# 英飞凌OPTIREG™ PMIC TLF35584QVHSx

## 勘误表

Reference: Datasheet Rev 2.0 (TLF35584QVHSx)

数据手册 Rev 2.0 (TLF35584QVHSx) 描述了 D11-step silicon 目标功能。

图 1 activated spread spectrum 时 SYN 输出中断 (FRE pin to GND - LF)

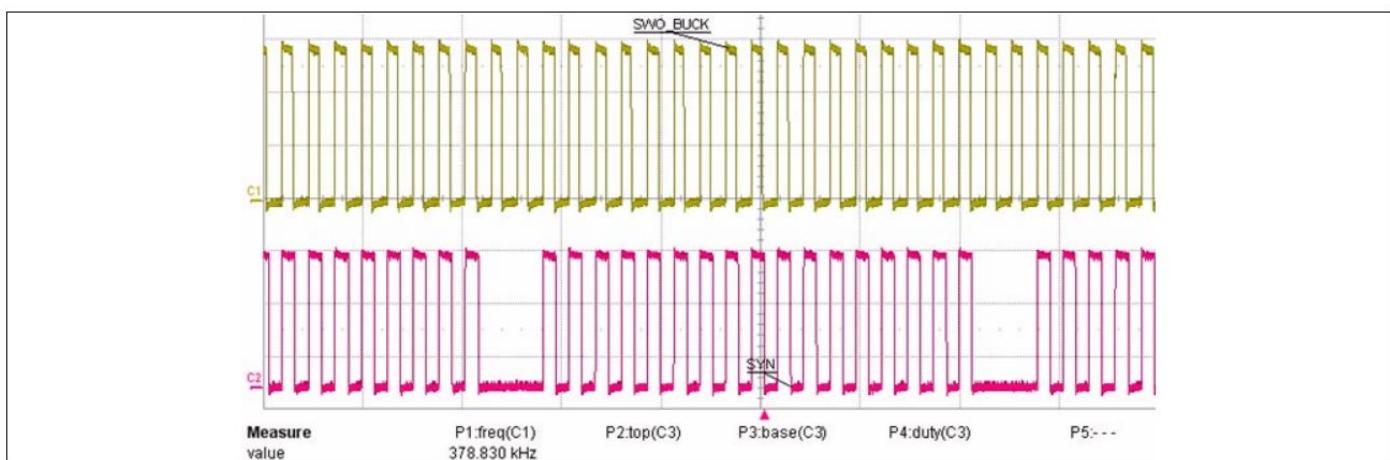
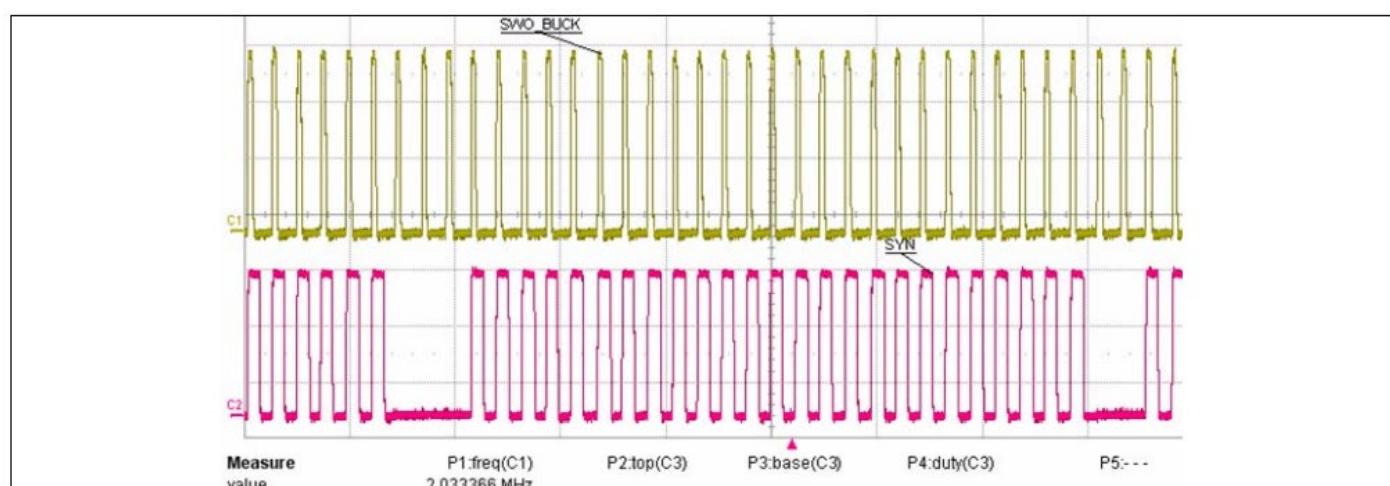
| Number | Function  | Description   |
|--------|---|---|
| 1      | Synchronization output signal with active spread spectrum | <ul style="list-style-type: none"> <li>There is a weakness of the D11-step silicon for the synchronization output signal for the optional core voltage regulator during activated spread spectrum.</li> <li>In case the synchronization output SYN is being used and connected to an external switched mode power supply, it should be taken into consideration that the SYN-output signal might be interrupted unintentionally in a random way for activated spread spectrum.</li> <li>In <a href="#">Figure 1</a> and <a href="#">Figure 2</a> it is shown how the signal of SYN might look like. The figures have been generated using the synchronization without phase shift (DEVCFG2.ESYNPHA = 0). For this configuration the SYN output signal will stuck to low signal temporarily.</li> <li>For configuration with 180° phase shift (DEVCFG2.ESYNPHA = 1) the stuck signal would be high level.</li> </ul> |

图3 复位输出 (ROT) 弱信号 - 示例：QUC 接地短路检测

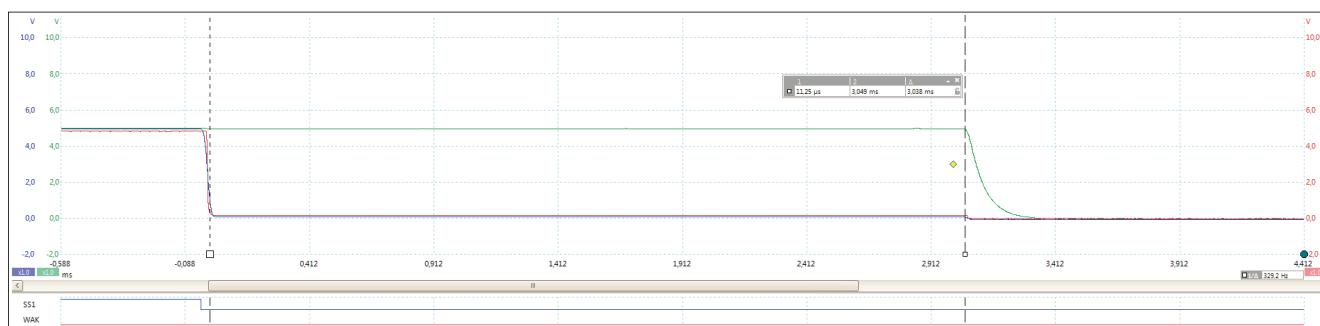
| Number | Function   | Description   |
|--------|--|---|
| 1      | Reset output ROT behavior in Move-to-FAILSAFE conditions | <ul style="list-style-type: none"> <li>There is a weakness of the D11-step silicon related to the reset output pin ROT, in case the TLF35584 moves to FAILSAFE state. In a safety context the reset function and the reset output ROT are considered to be QM, accordingly safety is not affected.</li> <li>The output driver of the open drain transistor in the reset output ROT is disabled together with the microcontroller supply LDO (QUC). According to the fact that the QUC is disabled/switched off in case of a Move-to- FAILSAFE event, the reset output is not longer pulled to low signal and is pulled up to QUC. As the QUC is disabled and the output cap is discharged by the load and an internal active pull-down of <math>\sim 80 \Omega</math>, this is reflected in a transient behavior which is shown in the figures below. The observation and relevance strongly depends on the failure case and its boundary conditions. These conditions are elaborated in the following list. <ul style="list-style-type: none"> <li>QUC shorted to GND: The voltage monitoring detects the UV and pulls down ROT. SS1/2 are going low and application is in safe state. QUC is shorted to GND and has 0V accordingly, but provides current (still enabled). After typ. 3ms TLF35584 moves to FAILSAFE state and disables the LDO and resets the output driver of ROT. Due to the short to GND ROT stays low as it is pulled to QUC. (no problem)<br/>Please refer to <a href="#">Figure 3</a>.</li> <li>QUC overloaded by current. The voltage monitoring detects the UV due to the decreased output voltage by current limitation or dropout voltage (only without boost) and pulls down ROT. SS1/2 are going low and application is in safe state. Due to the assertion of ROT the microcontroller is switched off and decreases its current consumption dramatically. The output voltage of QUC might recover into valid voltage range and the TLF35584 restarts in INIT state. (no problem)</li> <li>Continuous UV or short to GND on QST or VCI: The voltage monitoring detects the UV on the respective rail and pulls down ROT. SS1/2 are going low and application is in safe state. QUC continues to regulate to its nominal output voltage. After typ. 3ms TLF35584 moves to FAILSAFE state and disables all LDO and resets the output driver of ROT. The reset output might be pulled up to the discharging QUC (by the attached load and an active pull-down of <math>\sim 80 \Omega</math>). This might result into a temporary high level at ROT during the shutdown transition. A undervoltage monitoring of the microcontroller could prevent undesired start of the microcontroller operation. Please refer to <a href="#">Figure 4</a>.</li> <li>Continued on the next page.</li> </ul> </li> </ul> |

图5 复位输出 (ROT) 弱信号 - 示例：输出 QUC 处过压

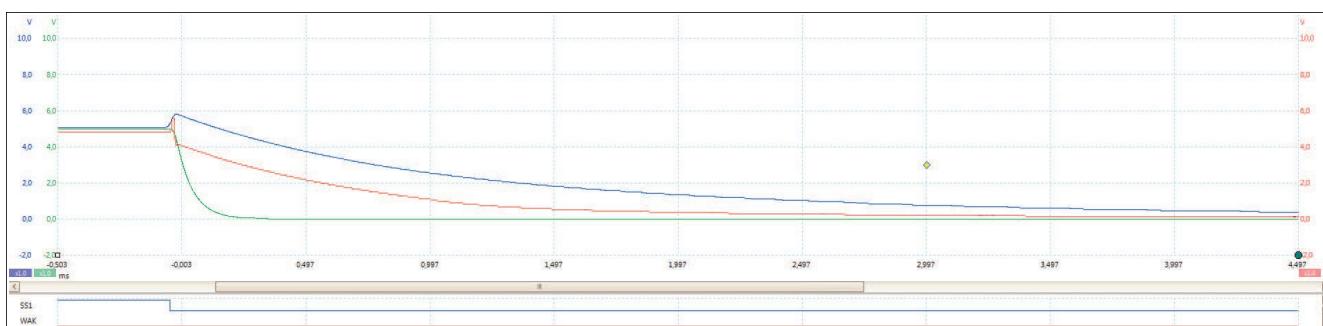
| Number        | Function   | Description  |
|---------------|--|--|
| 1<br>(cont'd) | Reset output ROT behavior in Move-to-FAILSAFE conditions<br>(cont'd) | <ul style="list-style-type: none"> <li>Continued:           <ul style="list-style-type: none"> <li>QUC shorted to an higher voltage rail: The voltage monitoring detects the OV on the QUC rail and SS1/2 are going low and application is in safe state. TLF35584 will move to FAILSAFE which is disabling QUC as well as all other regulators and activates the active pull-down of ~80 Ω on QUC output, trying to discharge the rail. The FAILSAFE state disables also the output driver of ROT. The reset output might be pulled up to QUC. This might result into a high level at ROT during presence of the external overvoltage. Still the application will be safely shut down during in this case by SS1/2. Please refer to <a href="#">Figure 5</a>.</li> </ul> </li> </ul>  |

图6 复位输出 (ROT) 弱信号 - 示例：STANDBY 转换

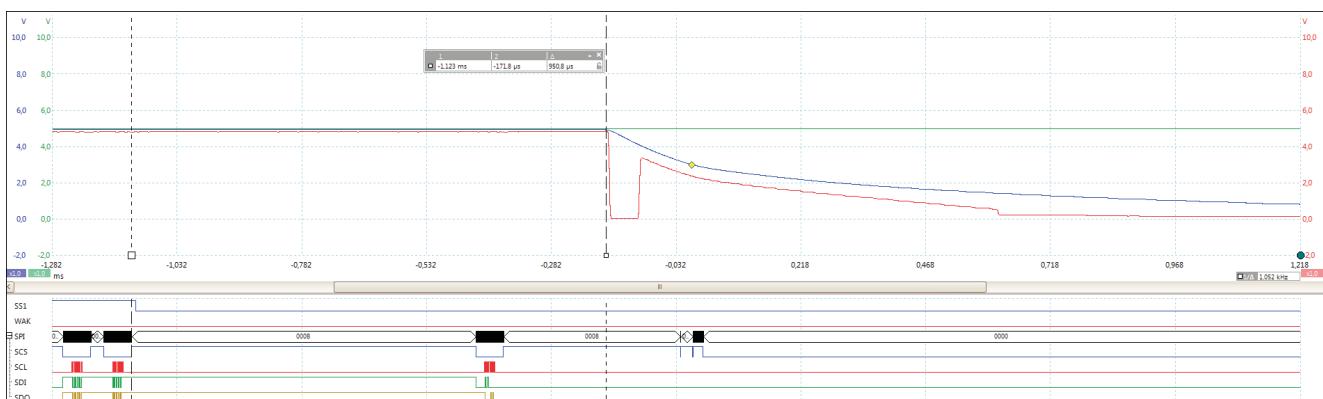
| Number        | Function   | Description  |
|---------------|--|--|
| 2             | Reset output ROT behavior for Move-to-STANDBY transitions            | <ul style="list-style-type: none"> <li>There is a weakness of the D11-step silicon related to the reset output pin ROT, in case the TLF35584 moves to STANDBY state. In a safety context the reset function and the reset output ROT is considered to be QM, accordingly safety is not affected.</li> <li>The output driver of the open drain transistor in the reset output ROT is disabled shortly after the microcontroller supply LDO (QUC). According to the fact that the QUC is disabled/switched off at the point in time when the device enters into STANDBY state (transition delay time expired or in case of QUC current monitoring usage after a decrease below the current threshold), the reset output shortly pulled to low, but pulled up to the output voltage of QUC right after. Nevertheless the output of QUC is actively discharged by the load and an internal active pull-down of ~80 Ω, this is reflected in a transient behavior which is shown in <a href="#">Figure 6</a> below.</li> </ul> |

图7 中断状态切换 NORMAL-STANDBY (MPS 引脚置位低)

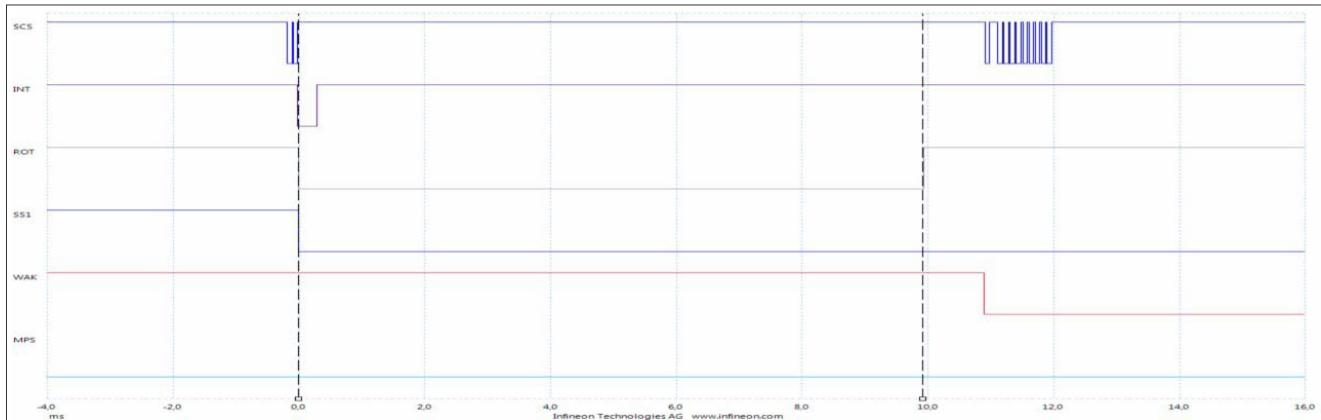
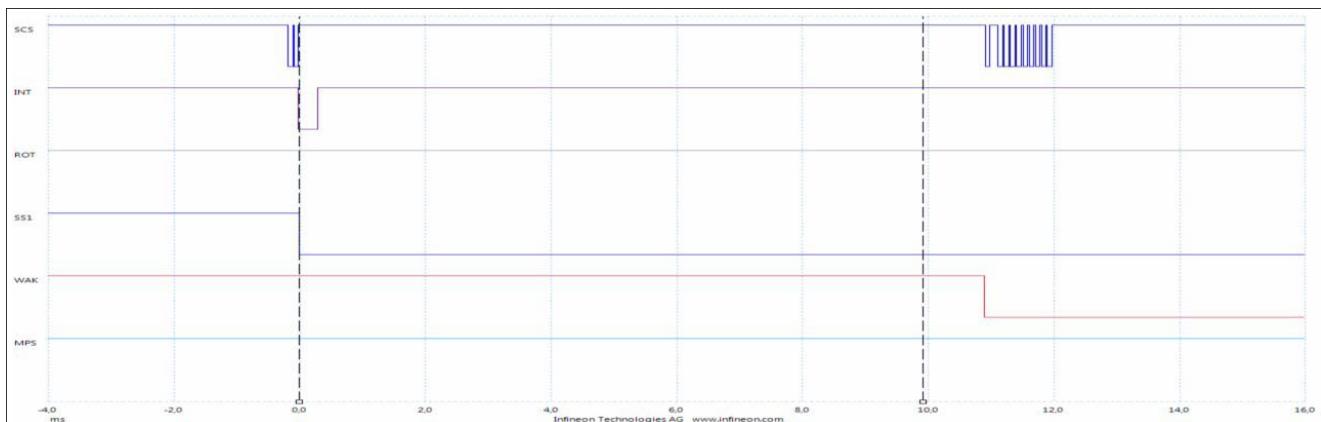
| Number | Function   | Description  |
|--------|--|--|
| 9      | Microcontroller programming support (MPS) influence to state transition NORMAL/WAKE to STANDBY | <ul style="list-style-type: none"> <li>The chapter 11.7 in the Datasheet Rev 2.0 (TLF35584QVHSx) describes influences to the overall device behavior of the TLF35584. Beside the described differences there is a unintended influences to the device behavior in case of microcontroller programming support being active (MPS-Pin high) for the movement NORMAL/WAKE to STANDBY. <ul style="list-style-type: none"> <li>For the particular case of an interrupted state transition from NORMAL/WAKE to STANDBY due to a wake-up event by WAK (level) or ENA(edge) during the transition, the TLF35584 is not triggering ROT to low when moving to INIT state. Accordingly the behavior with and without MPS being activated can be compared by <a href="#">Figure 7</a> and <a href="#">Figure 8</a>. Nevertheless the interrupted transition is triggering in both cases an interrupt event and reports the interrupted state transition by the interrupt register IF.SYS and the subsequent diagnostic register SYSSF.TRFAIL.</li> </ul> </li> </ul>   |
